ADDENDUM NO. 2

Colton MS Pavilion Building Addition

Colton Joint Unified School District
1212 Valencia Drive
Colton, CA 92324

DSA #04-123039

NORTH-SOUTH BUILDING SECTION SCALE: 1/8" = 1'-0" 2

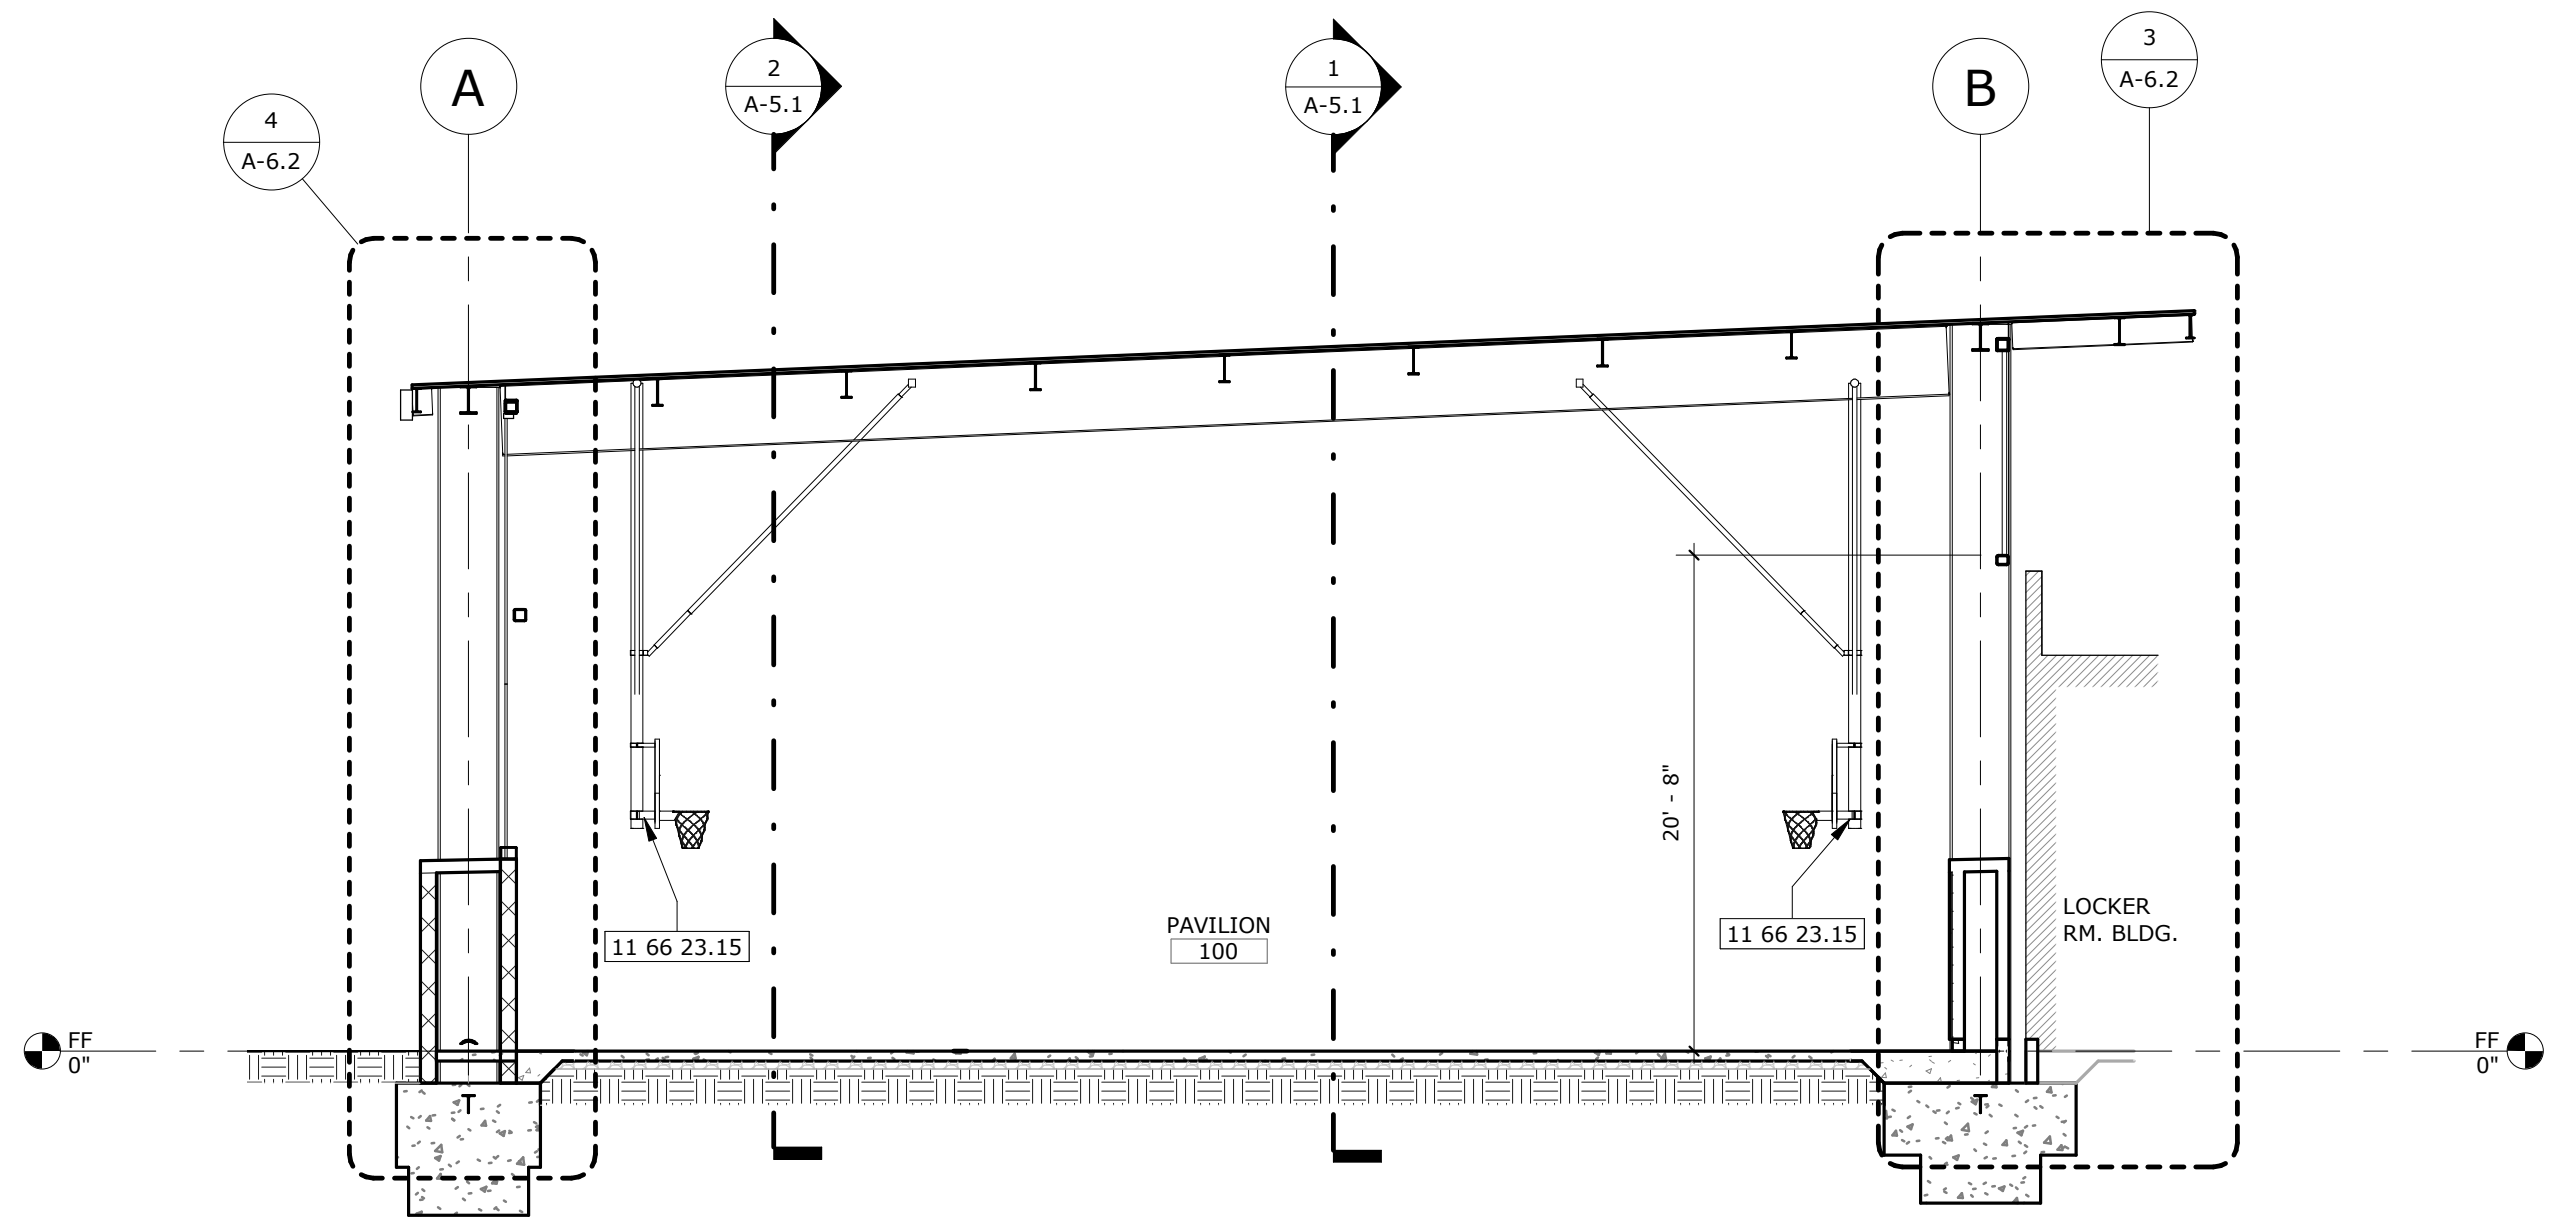
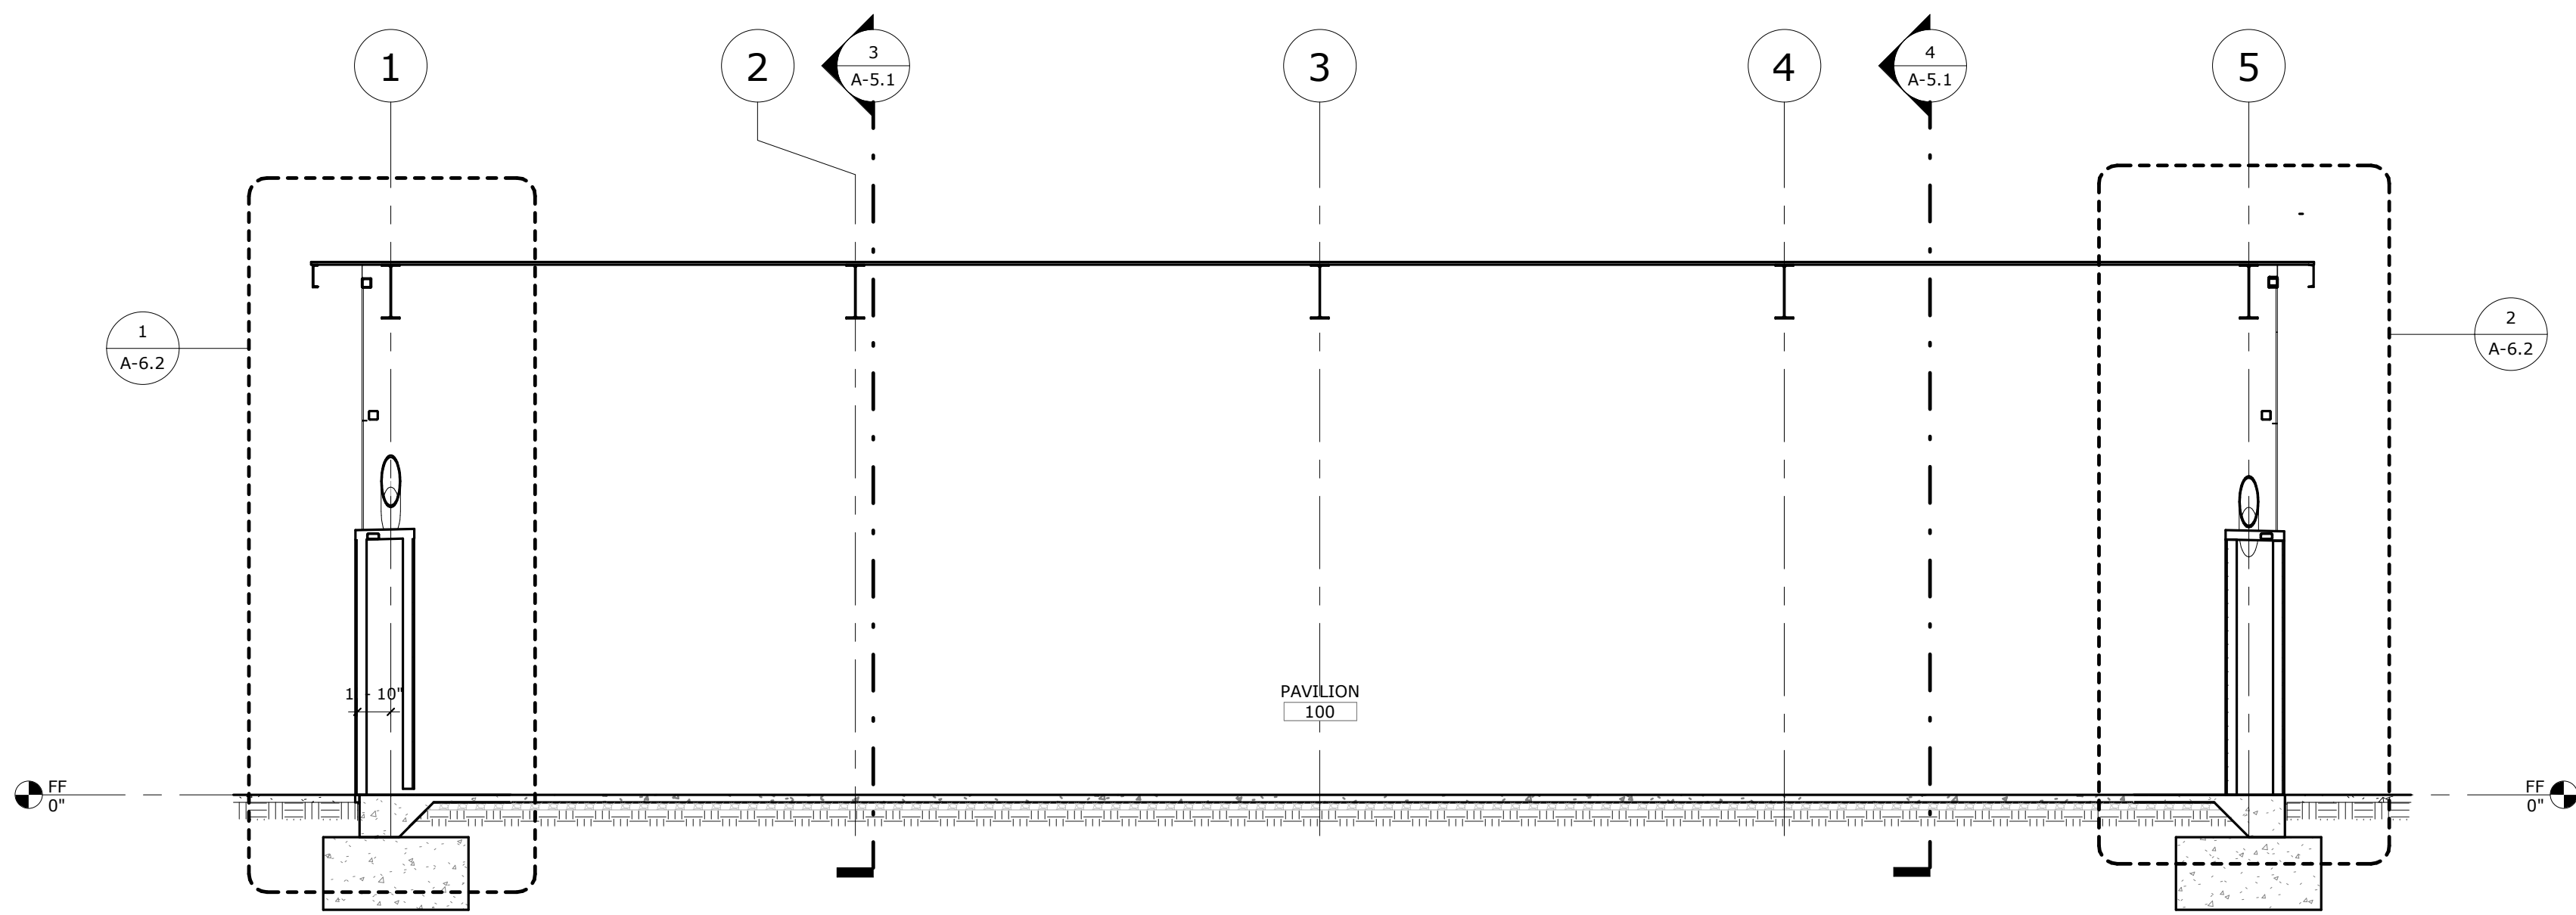
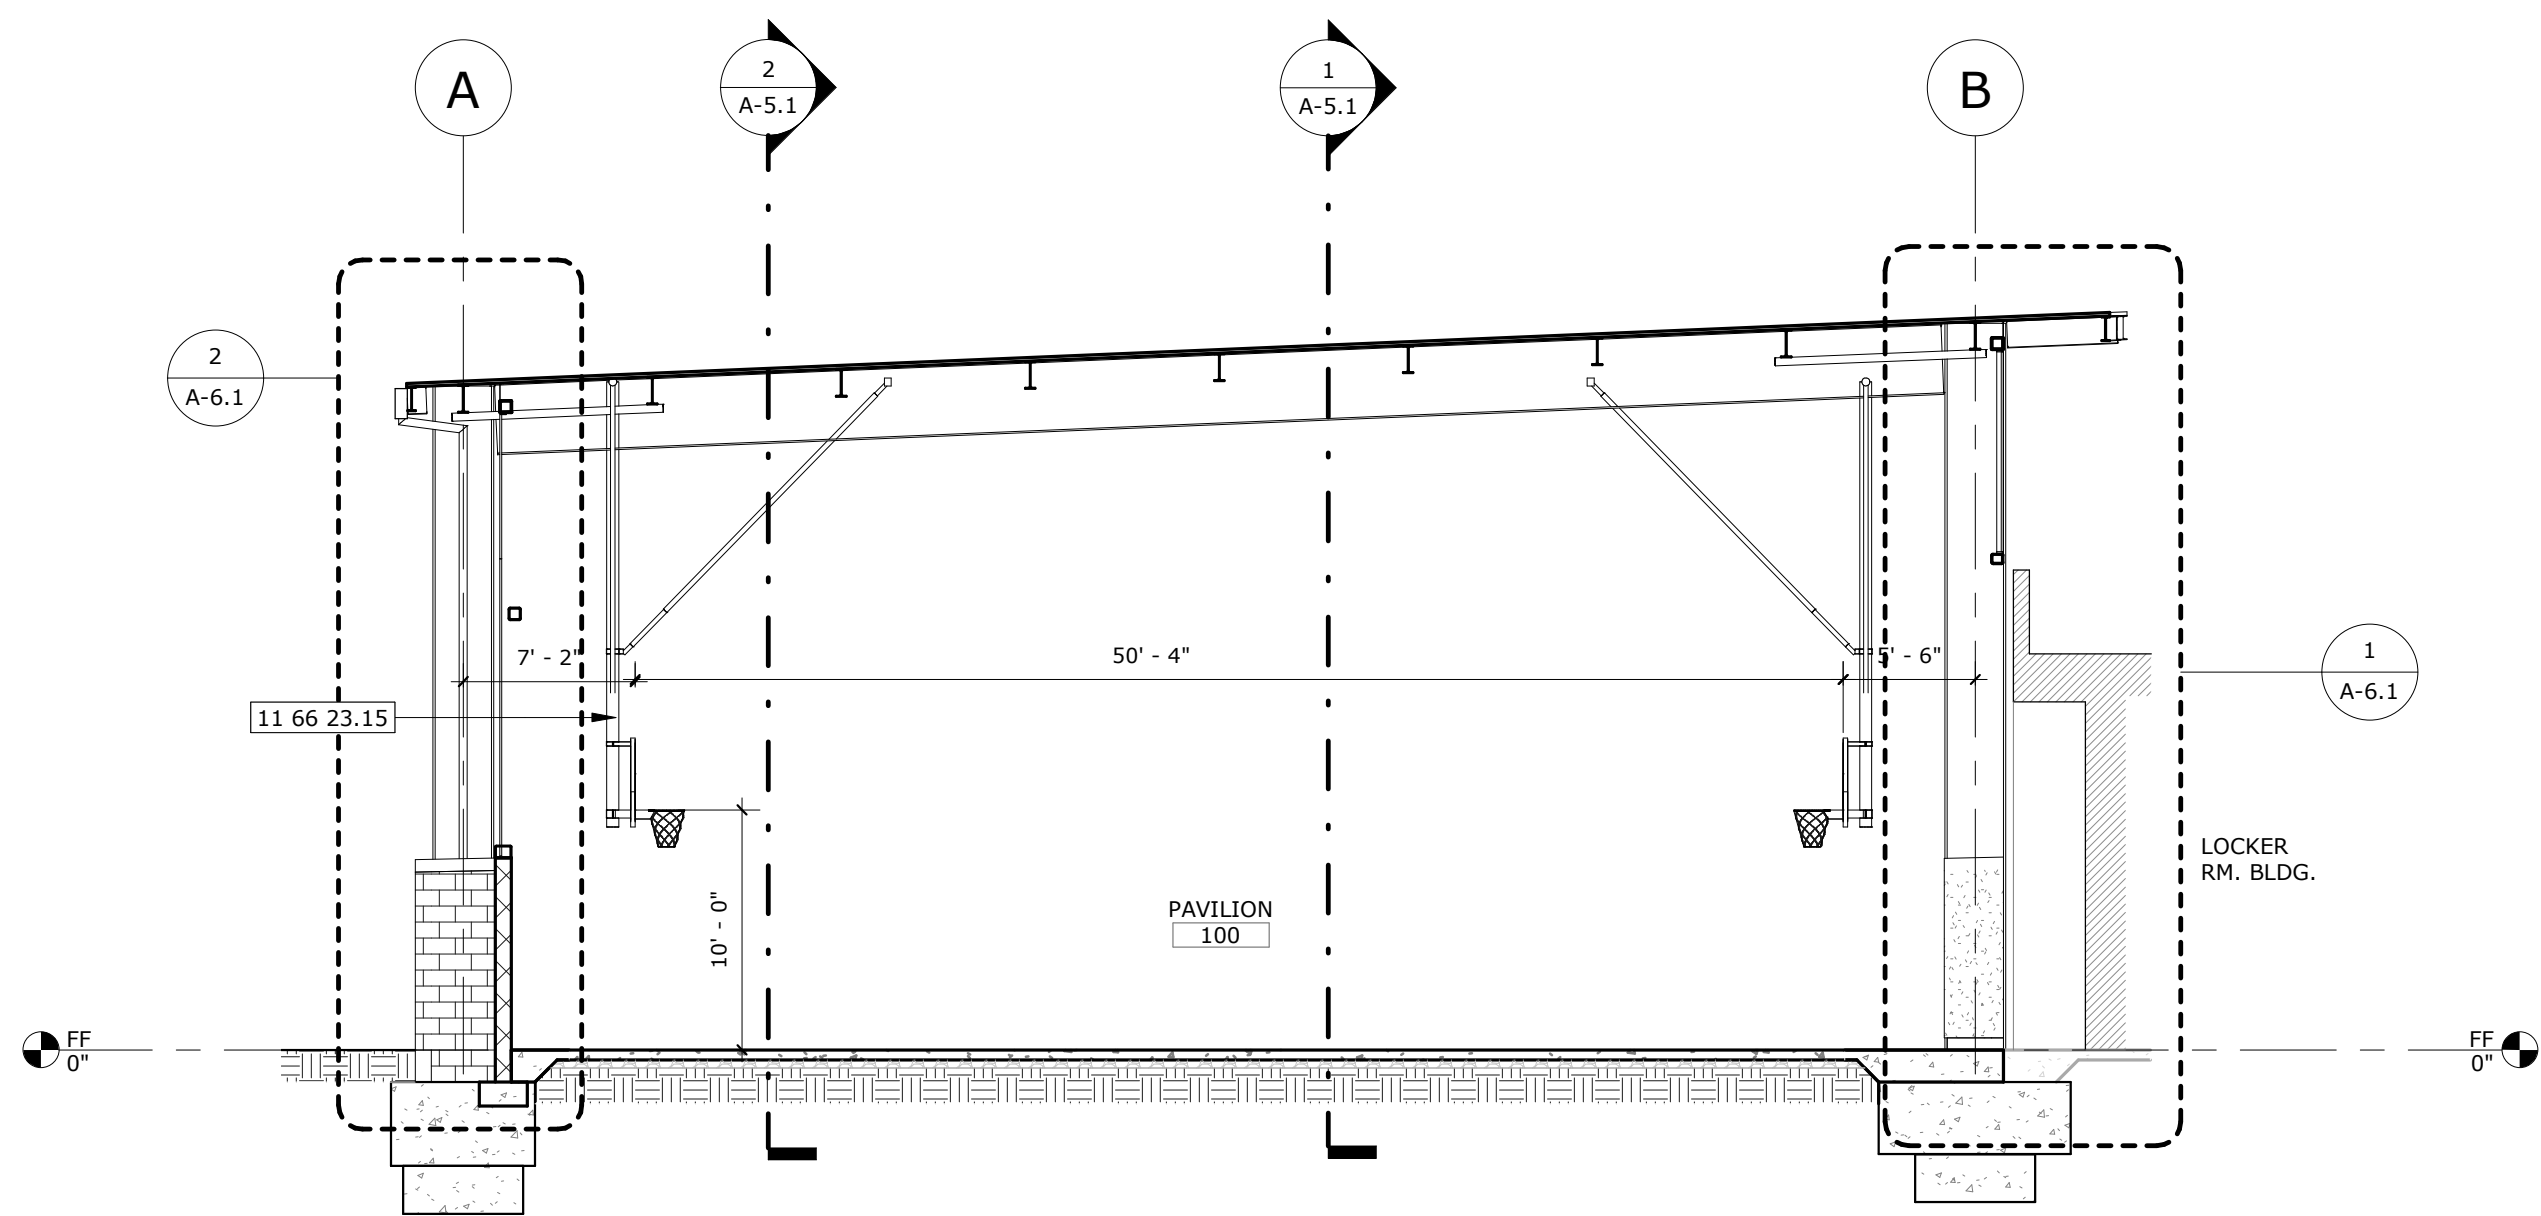
- Item No. 2.7 Reference Sheet A-5.1 – Building Sections:
2.7.1 Revised Keynotes and Details 2 per clouded areas.
- Item No. 2.8 Reference Sheet A-6.1 - Wall Sections:
